KANG STORAGE - 11041 E. HIGHWAY 24
LOT 1, ABIDING WORD LUTHERAN
CHURCH SUBDIVISION

Grading & Erosion Control Plans
El Paso County, Colorado

PCD FILE NO. PPR2620

GENERAL NOTES AND LEGEND

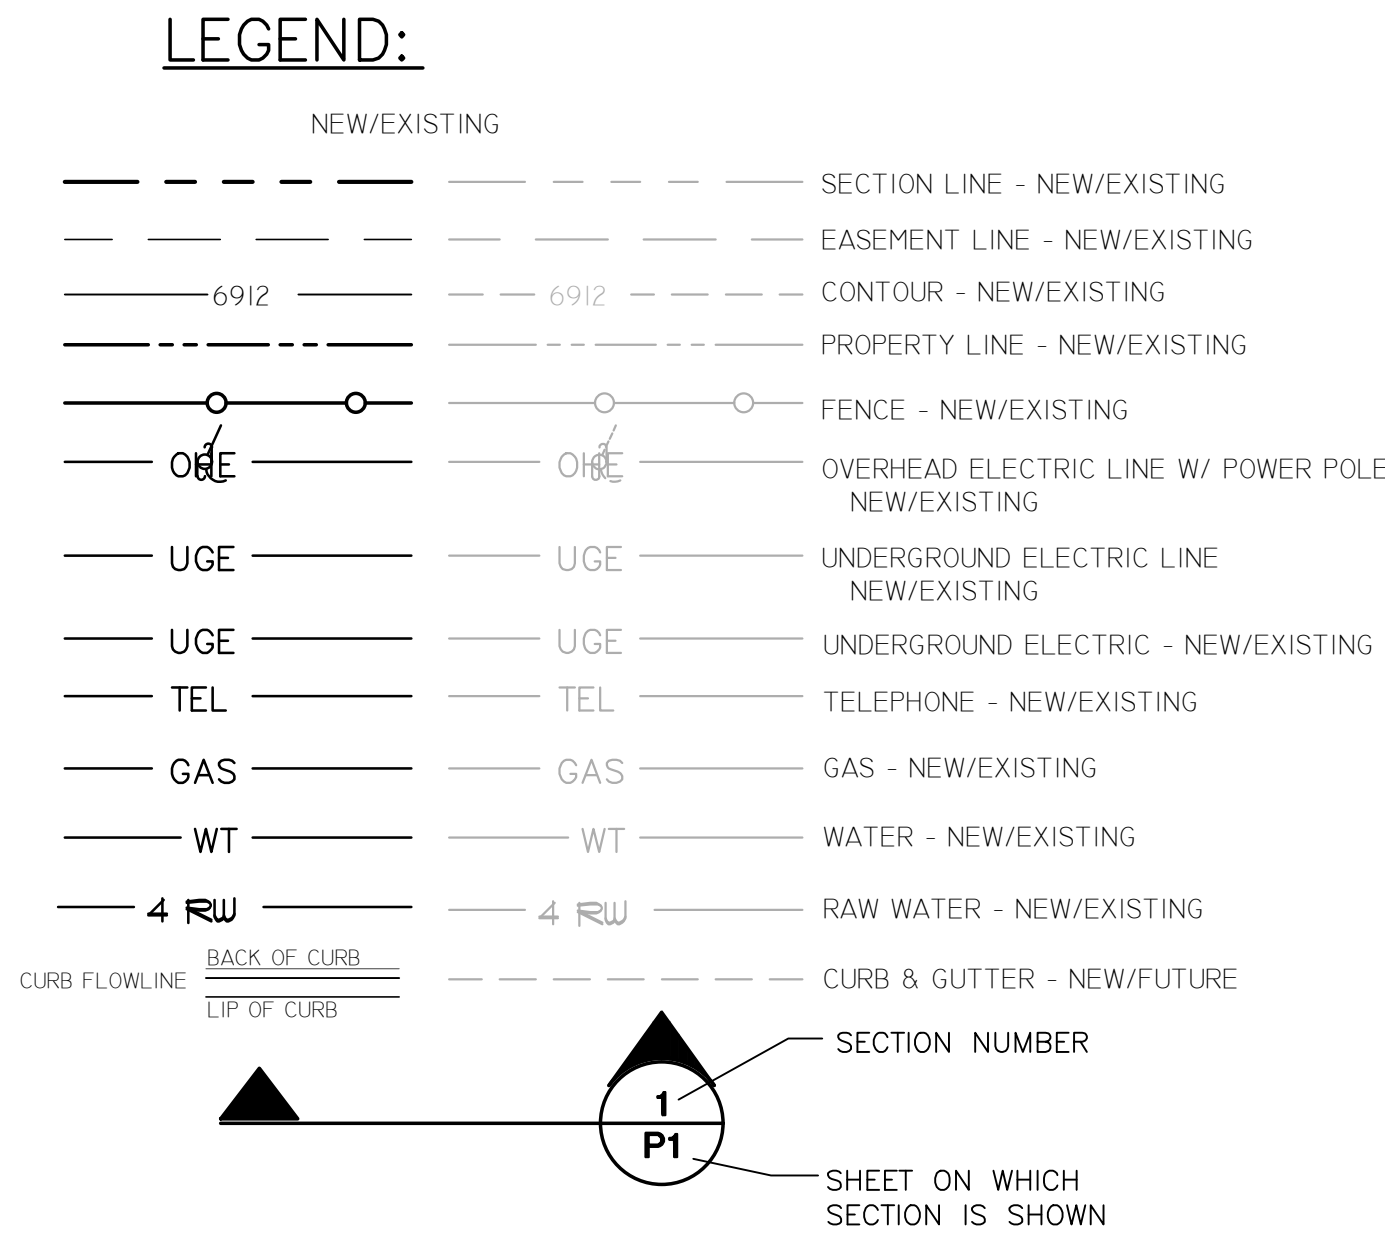
Please replace with most current version of County Signing and Striping Notes (revised October 2025)

<https://epc-assets.elpasoco.com/wp-content/uploads/sites/13/Standard-Notes-Signing-and-Striping-2026-Accessible.pdf>

**ORIFICE PLATE AND TRASH RACK
DETAILS AND NOTES (B)**
NTS

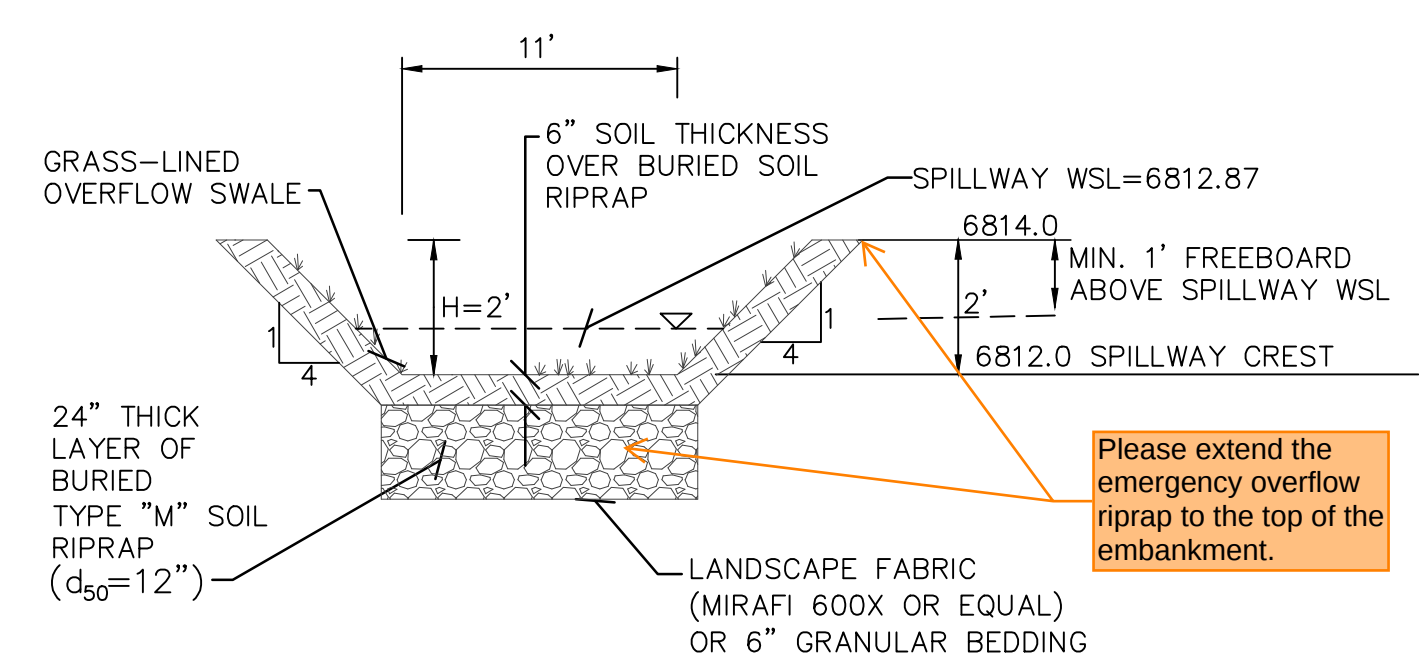
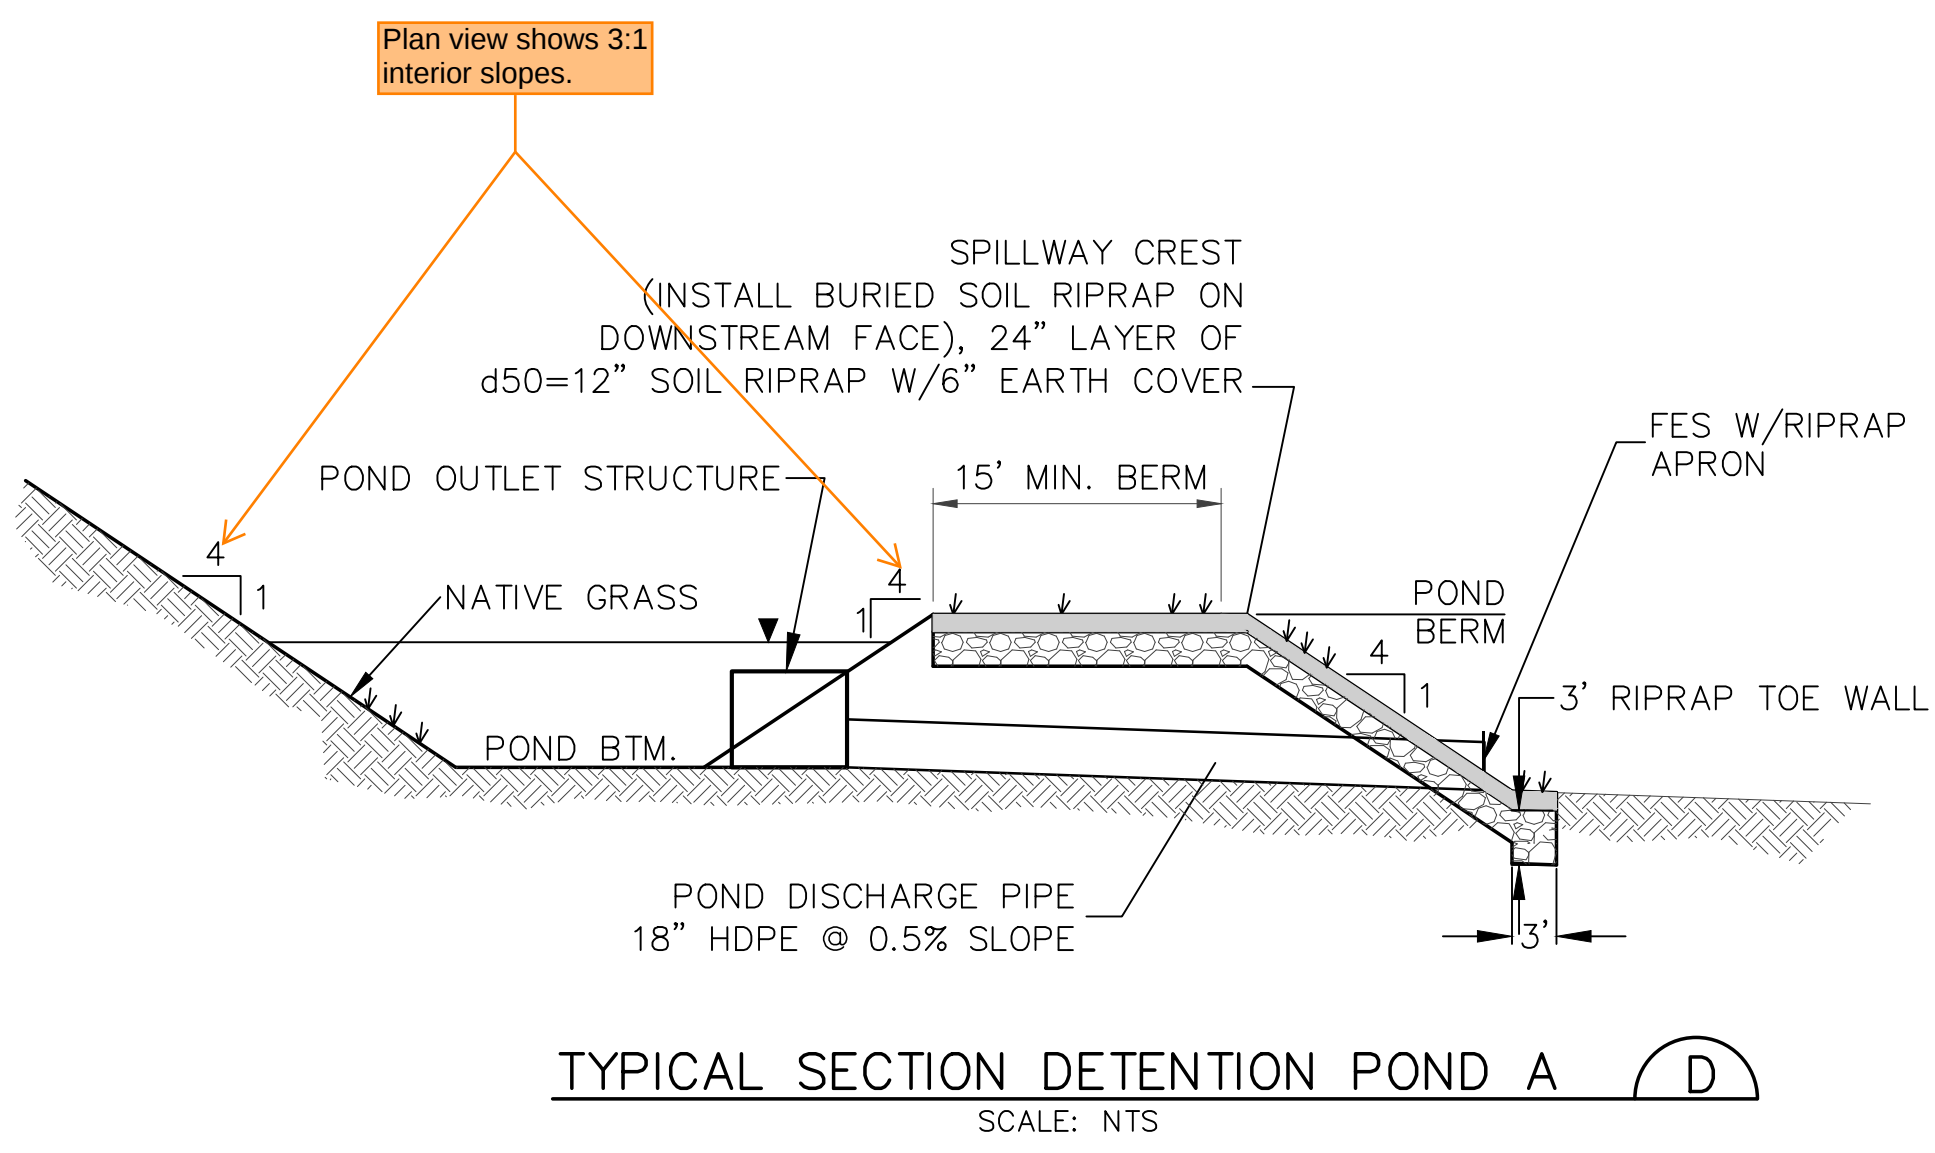
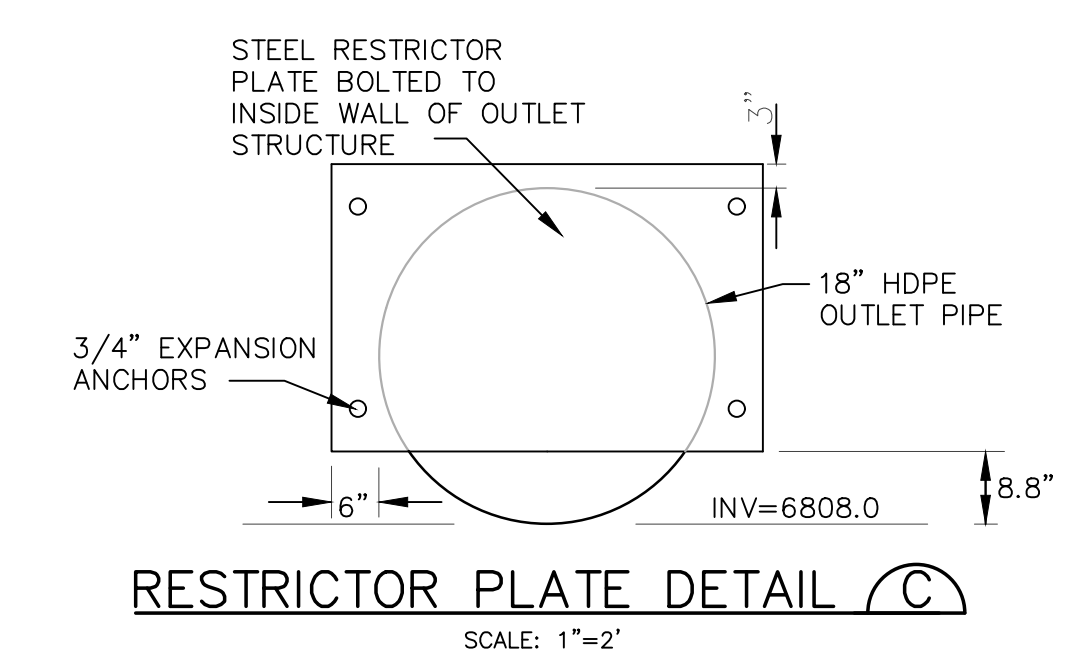
Provide more detailed gasket info like thickness, width, brand/model, etc. Based on input gathered from industry experts, below is the recommended gasket spec:

The gasket shall be made of 1/4-inch thick, 60 durometer EPDM rubber in a continuous sheet the size of the orifice plate. The sheet shall be placed between the orifice plate and the concrete wall, with the width of the overlap between the plate and the concrete. Openings shall be cut into the sheet corresponding to the plate bolt holes and the concrete wall opening, cuts made either by the contractor in the field or by the manufacturer. Or equivalent gasket approved by EPC. Note that caulk is not an approved equivalent and will not be accepted by EPC.
